Project: HMCS CARLETON

The following clarification relates to the specifications and drawings previously issued.

END OF TENDER ADDENDUM 004.

HMCS-CARLETON REPLACEMENT

ADDN-333-001

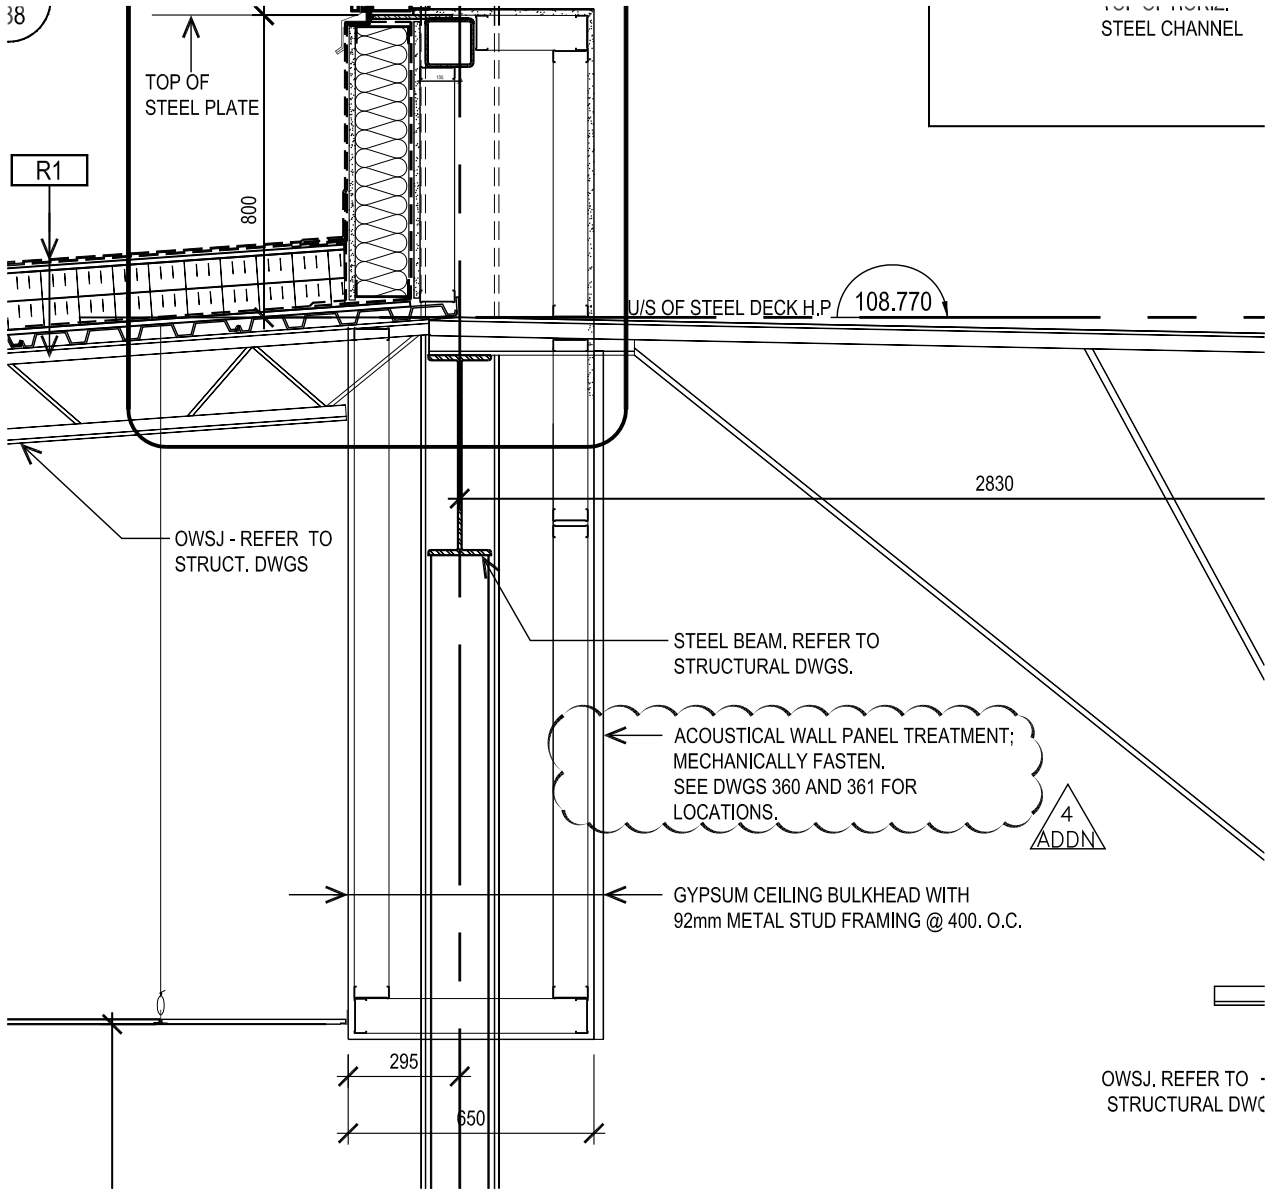
1. Revised notes for parapet details.
2. Revised note.
